Appl. No. 09/683,900 Amdt. Dated 8 October 2003 Reply to Office action of 8 July 2003

# Amendments t th Drawings:

The attached sheets of drawings includes changes to FIGs. 5 and 13 and an additional FIG. 15.

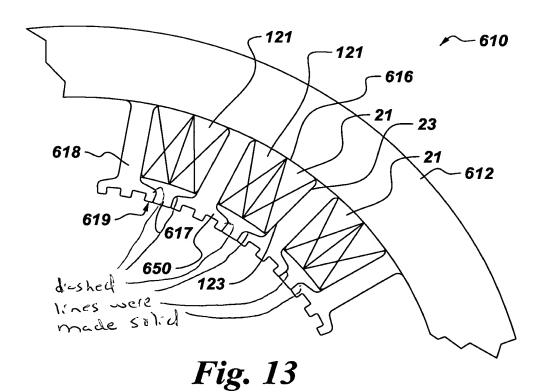
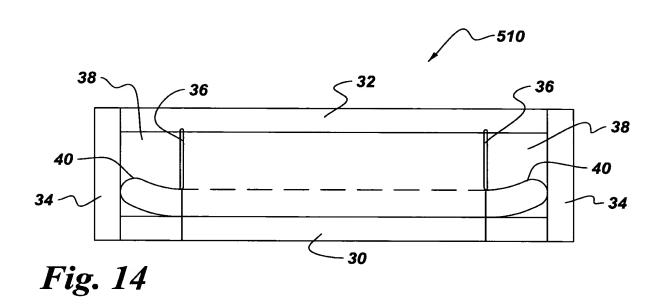
In amended FIG. 13, the dashed lines have been made solid, and in new FIG. 15, the old FIG. 13 has been modified and redrawn without the dashed lines.

Furthermore, the Office action states that discrete teeth are still not shown. Applicant asserts that these features are shown as elements 619 in FIG. 13 and described in paragraph 37. Although Applicant believes the drawings to be properly submitted as filed, to remove any ambiguity, Applicant is submitting herewith an amended FIG. 13 that changes the dashed lines to solid lines and a new FIG. 15 which is identical to the old FIG. 13 except for the removal of the dashed lines. The dashed lines had previously been used to indicate that FIG. 13 was representing two alternative embodiments of paragraph 37.
